Access Compliance Report

Public Rights-of-Way

Intersection ID: 2848	Main Street: DOWNFIELD_WOOD_DR	Cross Street: TUPELO_LN	Location: NW
ADA ID: 09939264A37A	Ramp Type: Perp	Initial Pass/Fail: Pass	Overall Compliance: No
Severity Score: 31.75			
Codes/Mitigation Info/Possible Solution		Field Measurements/Component Compliance

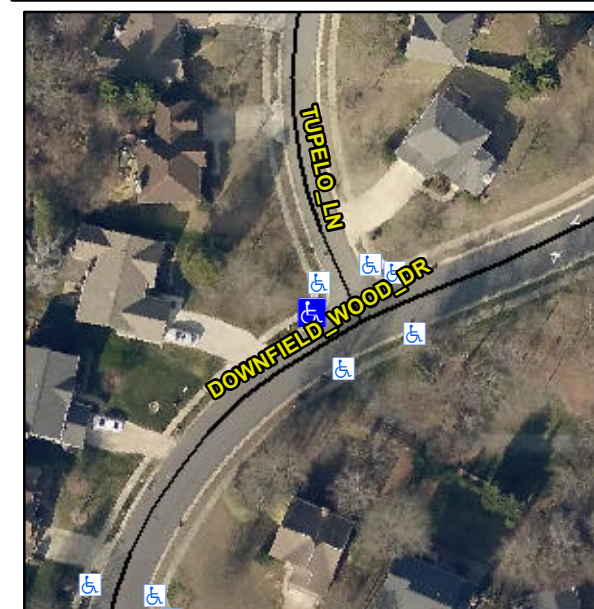
**Remove & Replace Entire Ramp.
Grind Gutter Lip.**

**R304.2.2, R304.2.1, R304.2.2-Perp,
R304.3.2-Para, R305, R302.7.2**
